Figure 12: Looking from Fleet Lane toward the disabled access ramp that serves the eastern adjoining commercial building No.12 Thomas Street.

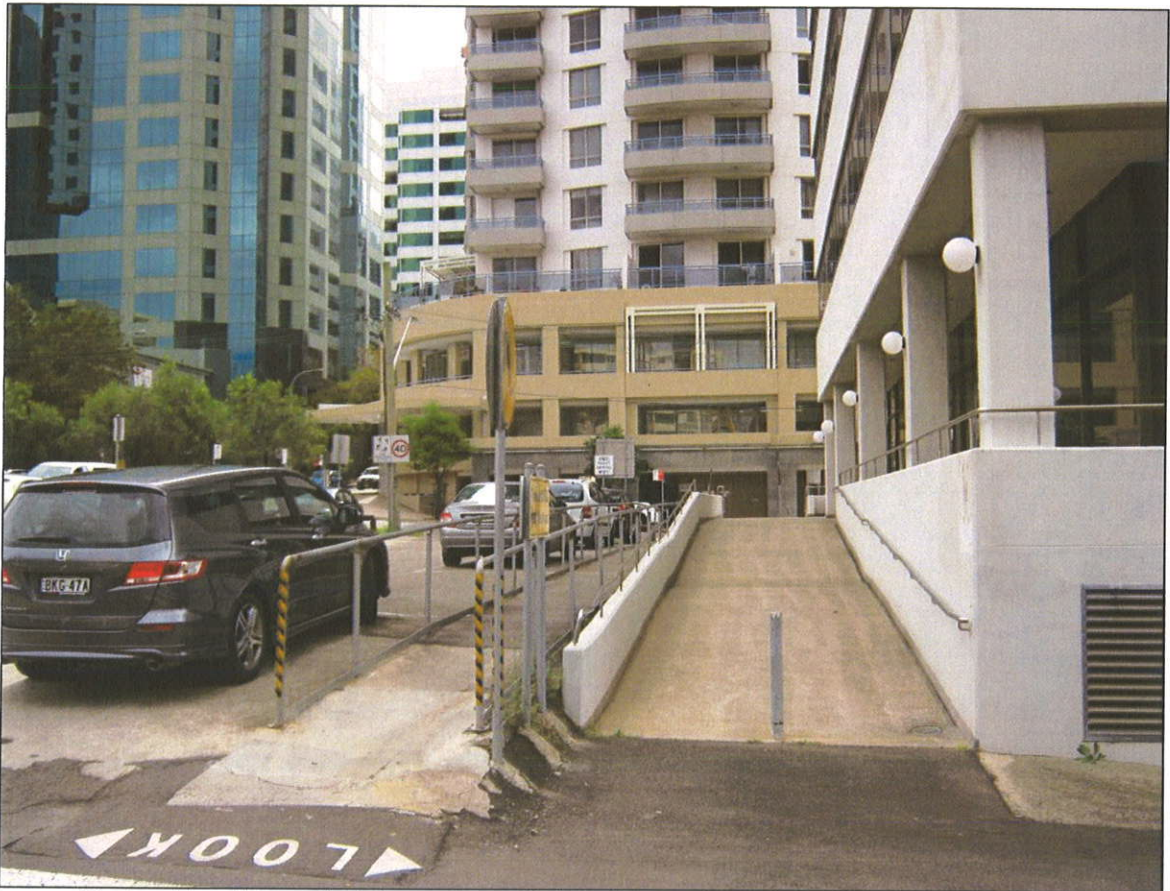
The proposed development will not alter the existing disabled access ramp on the western side of the building as this is wholly located on No.12 Thomas Street. It will however impact on the current ease of pedestrian access across the open car park on the subject site to this access point on Fleet Lane. The Department is aware of the concerns raised in this regard however considers that this ramp will remain unaffected and the expectation to rely upon the adjoining property for access is unsustainable and cannot justifiably be maintained at the expense of the reasonable development of the subject site.
